World Forum for Harmonization of Vehicle Regulations

1958 Agreement – Consideration of draft amendments to existing Regulations submitted by GRSP

Proposal for Supplement 3 to the 06 series of amendments to Regulation No. 16 (Safety-belts)

Submitted by the Working Party on Passive Safety *

Figures 1 to 7, item 2 of the Key, amend to read:

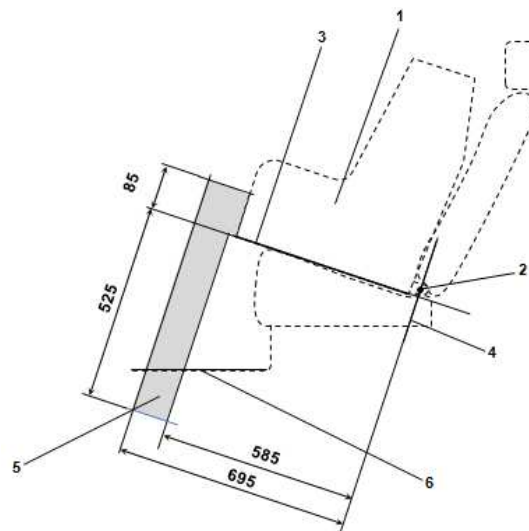
1. ...
2. Dashed line marks area where a support leg, or similar, of a specific vehicle CRS is allowed to protrude.
- ..."

"Figure 8

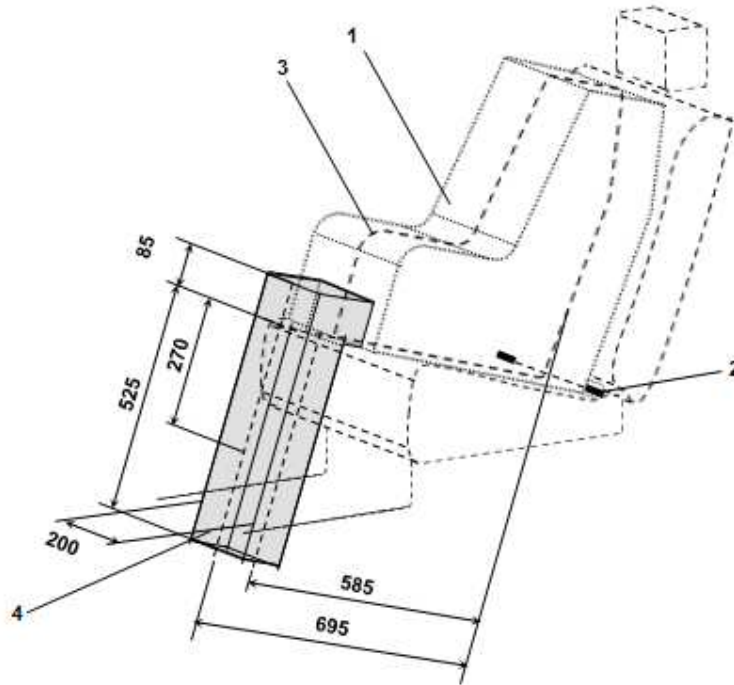
Insert new figures 8 and 9, to read:

Side view of the i-Size support leg installation assessment volume for assessing compatibility of the i-Size seating positions with support legs of i-Size child restraint systems

1. Child Restraint Fixture (CRF).
2. ISOFIX low anchorages bar.
3. Plane formed by the bottom surface of the CRF when installed in the designated seating position.
4. Plane passing through the lower anchorage bar and oriented perpendicular to the median longitudinal plane of the CRF and perpendicular to the plane formed by the bottom surface of the CRF when installed in the designated seating position.
5. i-Size support leg installation assessment volume representing the geometrical boundaries for an i-Size ISOFIX child restraint system support leg.
6. Vehicle floor.
